SIDESTAND LEG FOR 2003 MODEL FIREBOLT (XB9R) (PRODUCT PROGRAM NO. BP8)

Purpose

The Buell Motorcycle Company has elected to replace all sidestand legs on XB9R motorcycles, manufactured through July 9th, 2002. The new sidestand provides greater stability to the motorcycle when parked on sloped or uneven surfaces over and above the domestic/international standards with which it originally complied.

Figure 2. Old and New Sidestand Legs

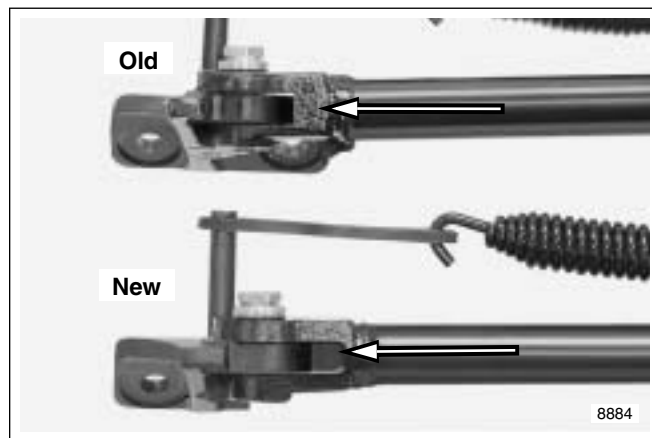
The part will be available on or before August 21, 2002. Part must be ordered as required and purchase price will be reimbursed through the warranty system. See CREDIT PROCEDURES. The replacement sidestand leg Part No. is: L0167.02A8.

Figure 3. Sidestand Assembly

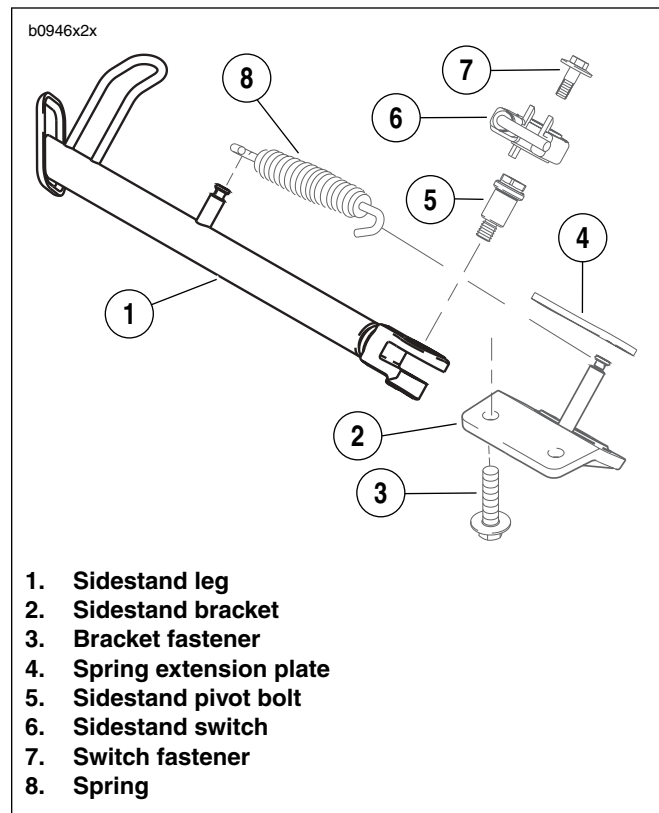
2. See [Figure 3](#). Remove sidestand switch (6).
 - a. Retract sidestand leg (1).
 - b. Remove switch fastener (7).
 - c. Extend sidestand leg.
 - d. Lift sidestand switch and slide to the right away from spring post on sidestand bracket (2) and leave attached to harness.
3. Remove sidestand leg (1).
 - a. Retract sidestand leg.
 - b. Remove sidestand spring (8) and spring extension plate (4) using SNAP-ON SPRING TOOL (Part No. HE-52B).
 - c. Remove sidestand pivot bolt (5).
 - d. Extend sidestand leg and remove.

- c. See [Figure 3](#). Install sidestand (1) and sidestand pivot bolt (5) tightening to 18-20 ft-lbs (24-27 Nm).
- d. Retract sidestand leg.
- e. Install spring extension plate (4) and sidestand spring (8) using SNAP-ON SPRING TOOL (Part No. HE-52B).

Figure 4. Lubricating Points (Shaded Areas)

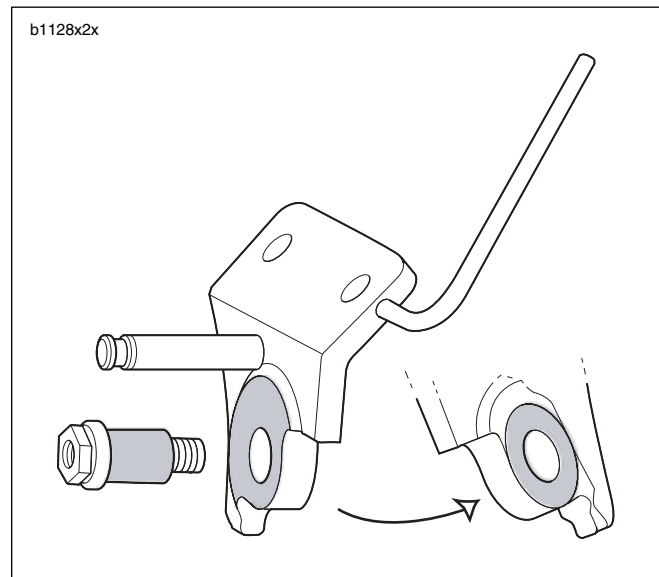
1. Install sidestand leg (1).
 - a. See [Figure 4](#). Lubricate sidestand pivot bolt and mating portions on sidestand bracket with WHEEL BEARING GREASE (Part No. 99855-89).
 - b. See [Figure 5](#). Apply LOCTITE 272 (Red) to threaded area (clevis) of sidestand leg.

Figure 5. Threaded Area for Loctite Application

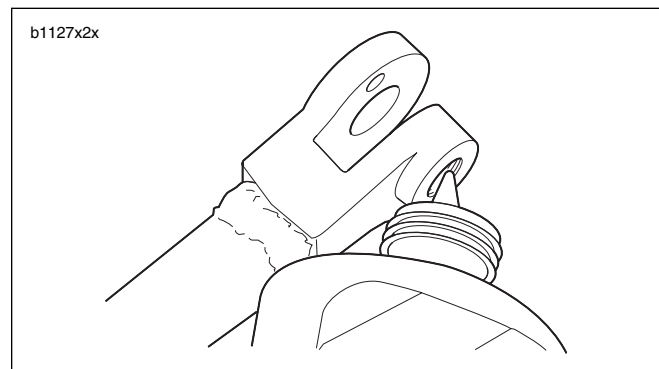
Applying LOCTITE to threaded area of clevis on sidestand leg, instead of threads on the pivot bolt, will eliminate build-up between clevis and sidestand bracket which can interfere with the applied lubricant.
